SERVICE 		4
		B0200048

SB, 340, 345, 350, 346, 351, Carburettor, 2002-08

N compl 503 28 18-12 Walbro HDA 195
compl 503 28 18-13 Walbro HDA 196 (EPA)

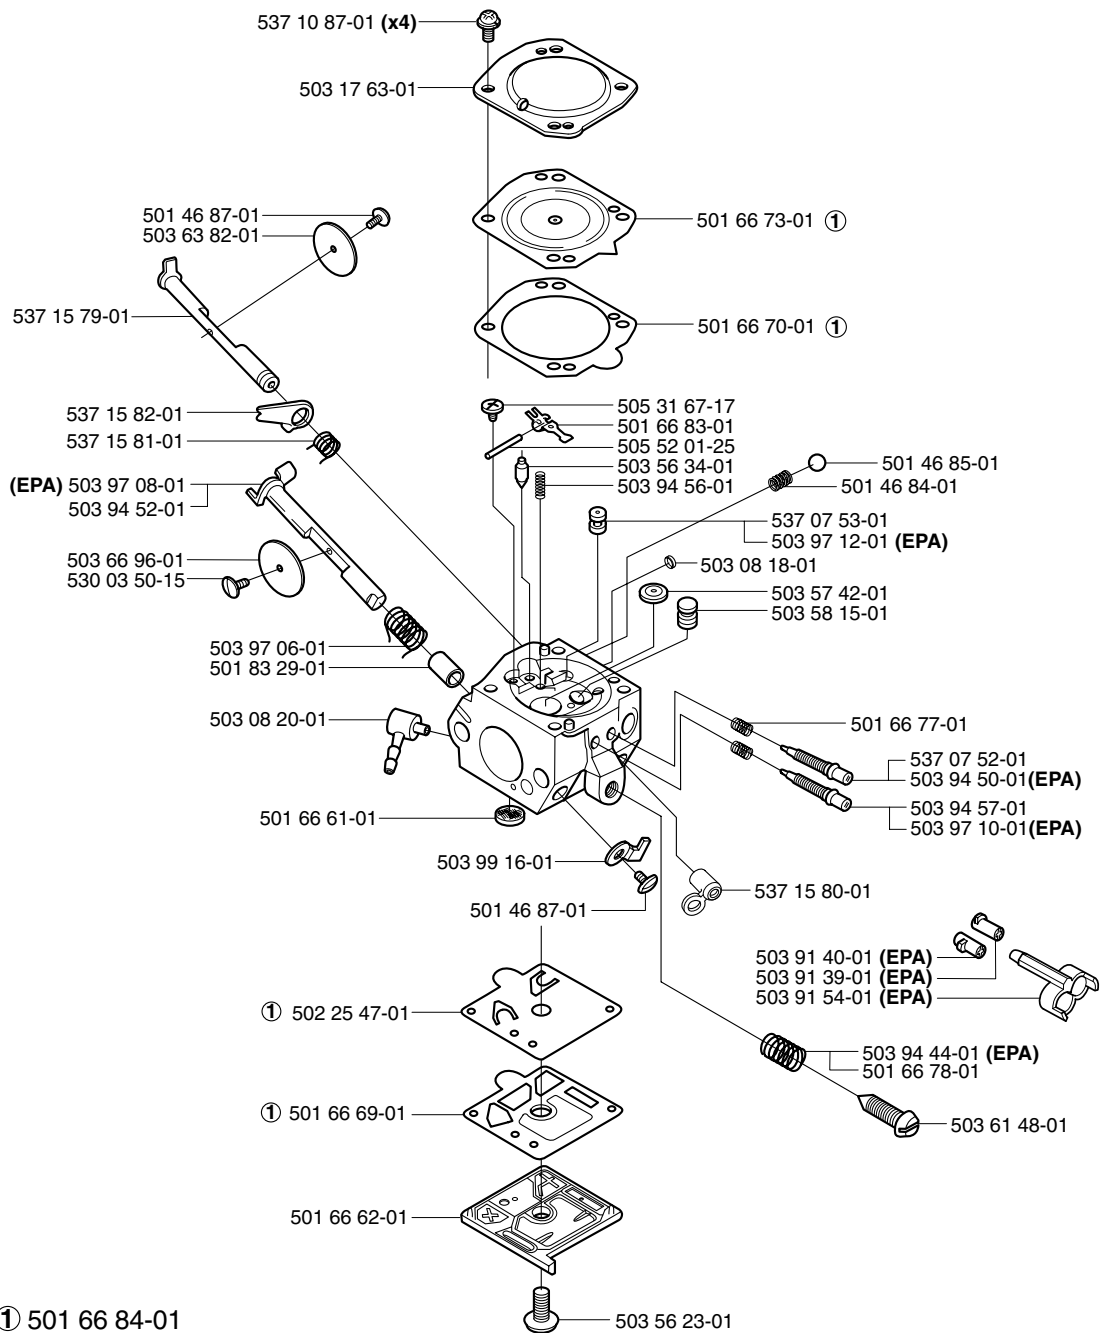
A mechanical catch has been introduced for the choke valve to ensure a better seal between the carburettor housing and choke valve and to improve starting abilities.

The paper pump gasket for the carburettor assembly has been replaced with a rubber gasket.

New and old parts are fully compatible.

New ref. no.	Description	Excl. ref. no.	Remark
503 28 18-12	Carburettor HDA 195	503 28 18-03	340, 345, 350, 351
503 28 18-13	Carburettor HDA 196	503 28 16-14	EPA, 340, 345, 350, 346, 351
501 66 69-01	Pump gasket	503 80 06-01	
537 15 81-01	Spring	503 56 25-01	
537 15 82-01	Lever	504 86 04-08	
537 15 79-01	Choke shaft	503 94 53-01	
537 15 80-01	Lever		
501 46 85-01	Choke stop ball		
501 46 84-01	Choke stop spring
